**Operator: 8 NORTH**

**Location Name: WILSON 1160-29-22**

**Loc ID: 415293**

**Inspection: 696301576**

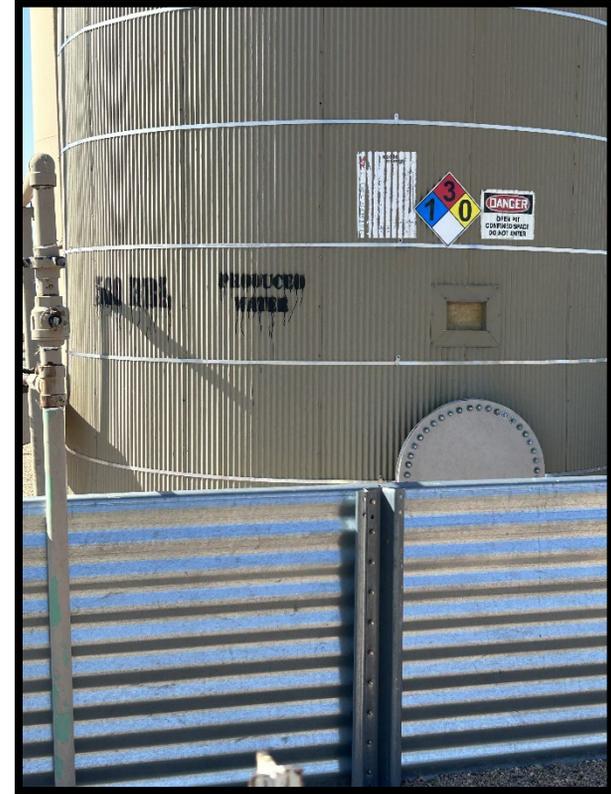
**CA:** Produced Water Tank - Missing Capacity and NFPA is fading, see photos. Comply with Rule 210.d.

**CA:** Stained Soil at Wellhead, see photos. Corrective Action: For localized stained soils or oily waste - "Properly dispose of oily waste in accordance with 907.e."

**CA Resolution:** Operator has appropriately installed NFPA and capacity labels on the produced water tank.

**CA Resolution:** Operator has provided photo evidence to show that the stained soil has been appropriately removed/cleared and mechanical issues leading to the leak have also been addressed.
